UNITED STATES PATENT AND TRADEMARK OFFICE

| APPLICATION NO. | FILING DATE | FIRST NAMED INVENTOR | ATTORNEY DOCKET NO. | CONFIRMATION NO. |
|--|-------------|----------------------|---------------------|------------------|
| 10/642,343 | 08/18/2003 | Josef Giessler | 029777-015 | 1920 |

Office Action Summary

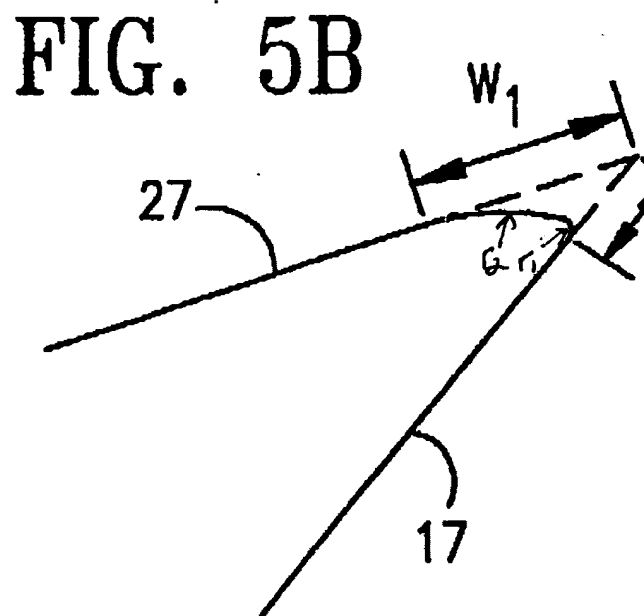
BRITZKE ET AL. teaches a rotary cutting tool (10) comprising a shank (11) and a cutting part (13) disposed at the front end of the shank and defining an axis of rotation (16) and an outer periphery of the cutting part (13) having cutting grooves (15) extending helically to the front end face of the cutting part and each cutting groove disposed rearwardly of the end face defining a helix angle with a plane containing the axis while having cutting edges formed at the edge ('447, Figure 1 and Col. 3, lines 26-38). BRITZKE ET AL. also teaches in figures 5, the helix angle being larger than a cutting-face angle formed between the end face and a front end section of each cutting groove, the cutting-face angle continuously transforming into the helix angle. BRITZKE ET AL. also teaches in figures 5 the cutting-face angle transforming (via a transition) into the helix angle along a constant radius of curvature (figure 5A) as well as the cutting-face angle transforming into the helix angle along a plurality of radii (figure 5B) whereby a first radius adjoins the cutting edge, and a second radius adjoins the helix angle (the first radius being smaller than the second radius: see figure below).

Regarding claims 5 and 6, BRITZKE ET AL. teaches in Figure 5B, the transition between the cutting-face angle and the helix angle extending substantially parallel to the axis for a distance shorter than a diameter of the tool as well as shorter than half the diameter of the tool (all see figure 4 for the diameter of the tool). Regarding claims 9 and 10, BRITZKE ET AL. teaches the rotary cutting tool comprising a drilling tool or a milling tool ('447, Col. 5, lines 55-59).
